ADDENDUM NO. 1

OWNER: Municipality of Southwold
DATE: June 11, 2019
PROJECT: Shedden Athletic Park Washroom and Pavilion
JOB NUMBER: 219073

drawing no. : **SP1**

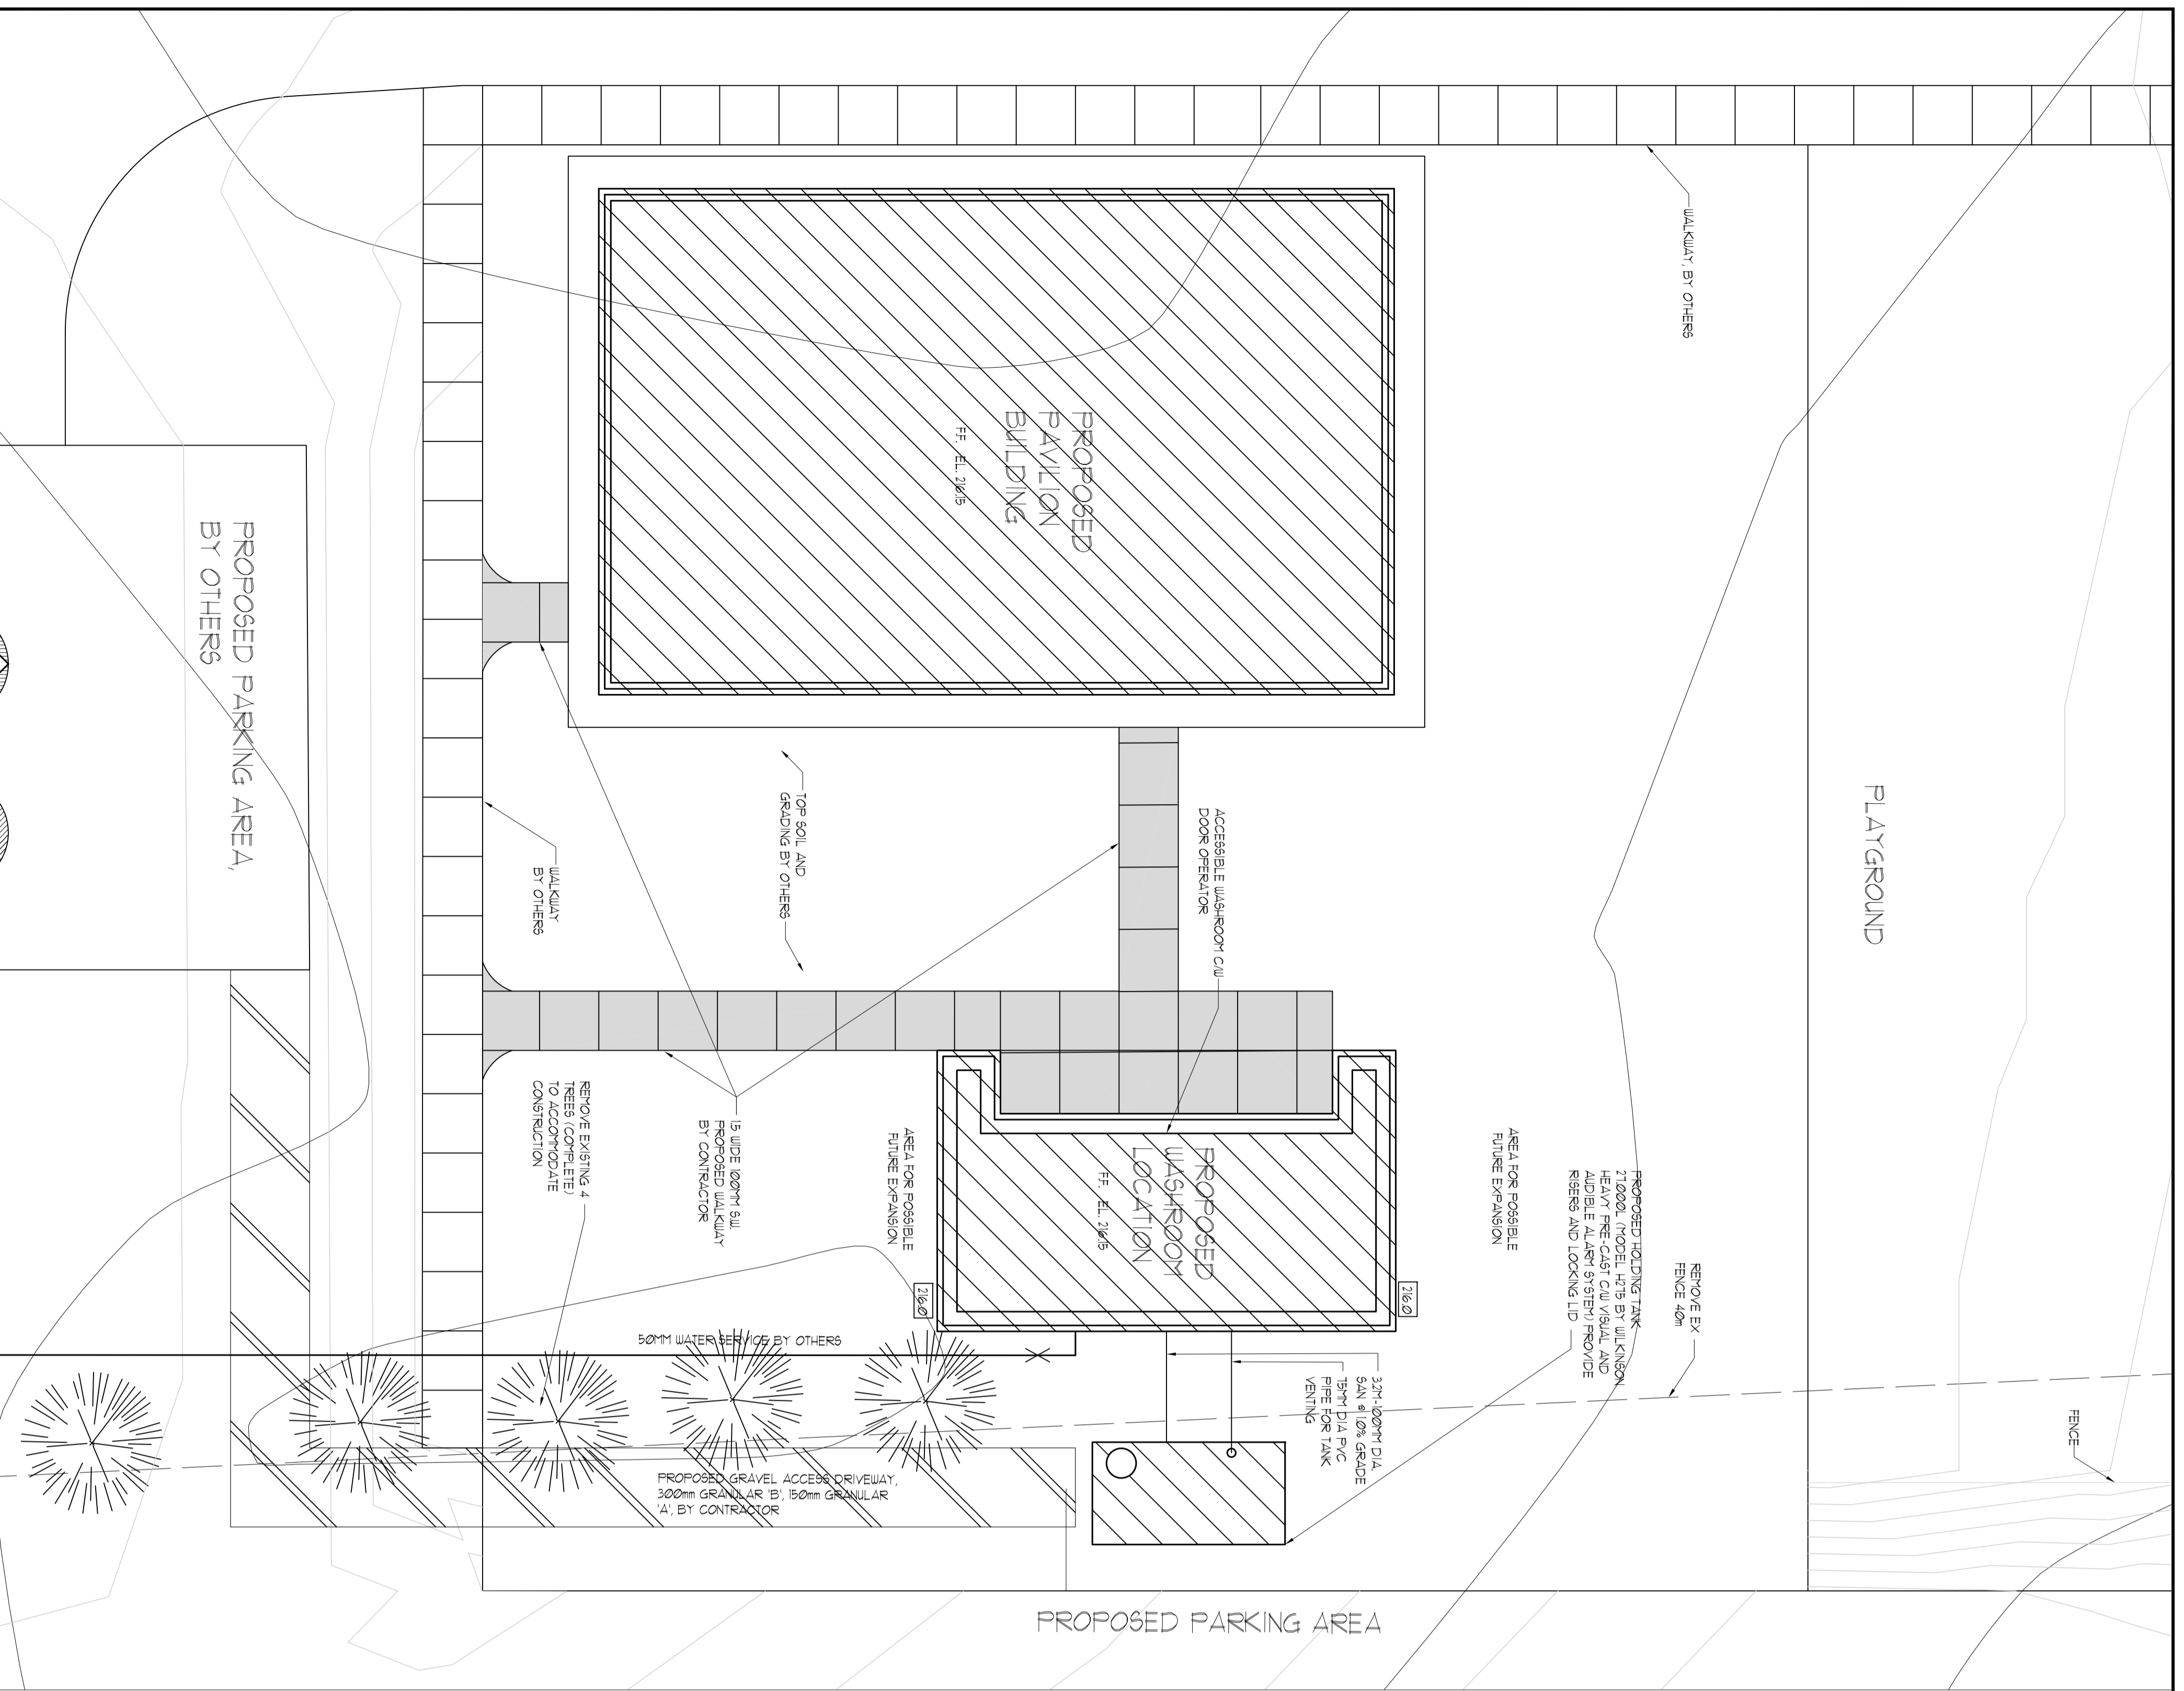
1. Closing date has been moved for Friday June 21 at 2pm to **Monday June 24th at 12pm.**
2. Please find attached SP1 that identifies location of buildings and scope of site work.
